Bucks Creek 1101- PM# [REDACTED] Overview Map

Subject: O8W-PM [redacted] - Bucks Creek 1101 Phase 1,2&3 - Pre-Engineering Meeting

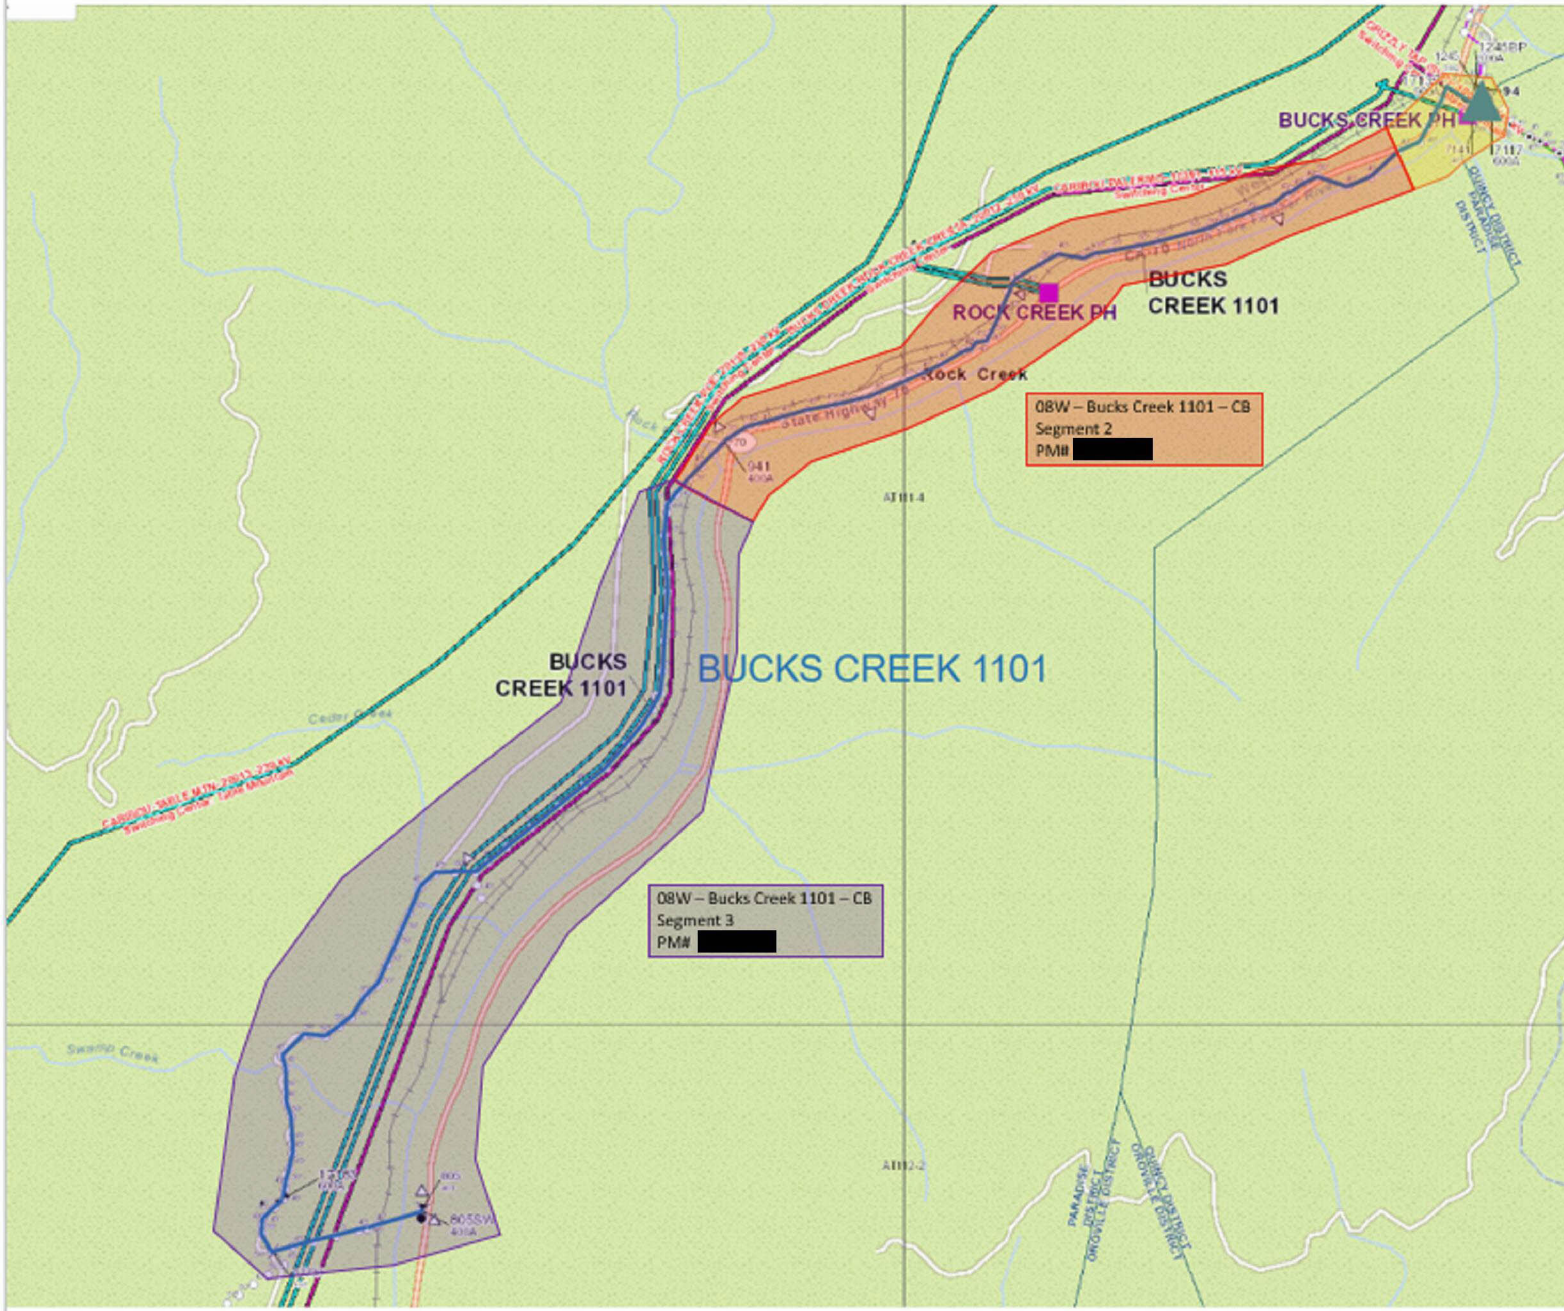
Attached are the 'base-map' limits in a kmz. file. As you will see, we need our base-map to go about ~100' into the tunnel at the south end (see pedestal in picture below....please begin about ~50 beyond this point which is about ~100' beyond the Cresta Dam).

We want to end the base-map at the sign location below which is roughly at MM (Mile Marker) 5.10.
